Subject: Re: Data for Parcel C

Lily Lee Cleanup Project Manager Superfund Division U.S. Environmental Protection Agency, Region 9 75 Hawthorne St. (SFD-8-3) San Francisco, CA 94105 Tel: 415-947-4187, Fax: 415-947-3518 For information on Superfund in general: www.epa.gov/region9/superfund For information on Hunters Point Naval Shipyard: www.epa.gov/superfund/hunterspoint Anita Singh

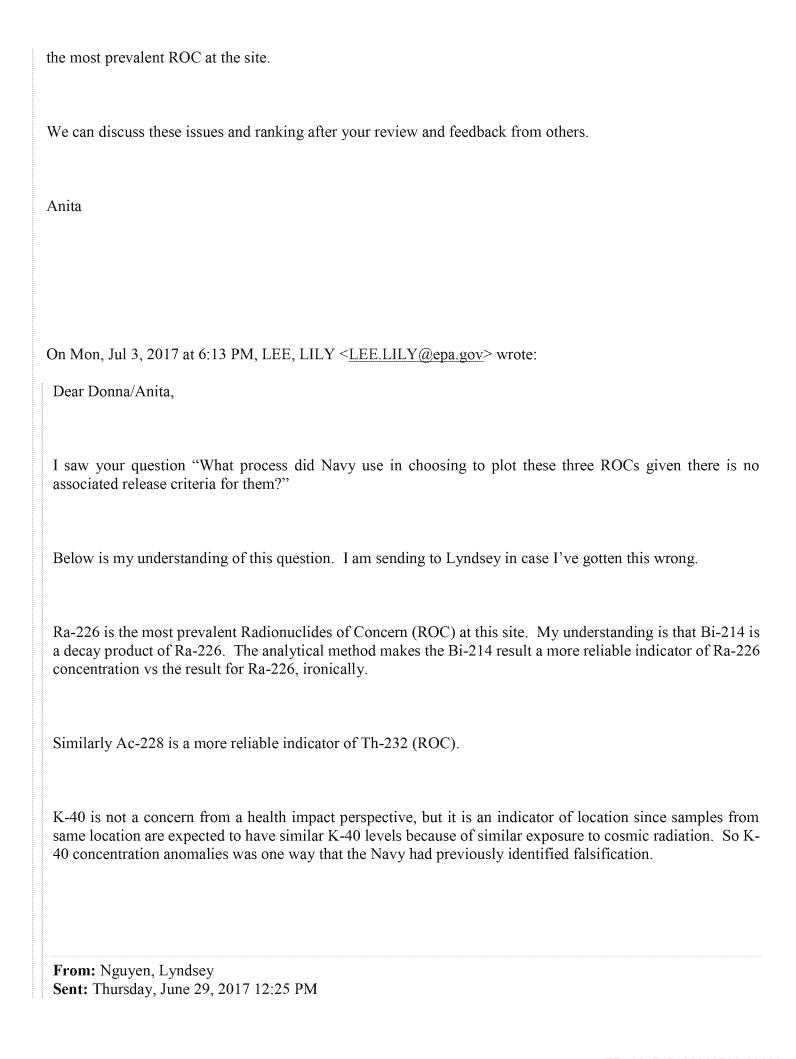
Note that more than 50% of TUs from parcel C fall in this category with data only from FSS phase.

Per our understanding described above, TUs with FSS data satisfying release criteria do not require further PCA evaluations.

Based upon high variability in FSS data, we have given non-zero scores (0.5) for some of those TUs.

However, those TUs may not require further investigation if FSS data satisfy release criteria.
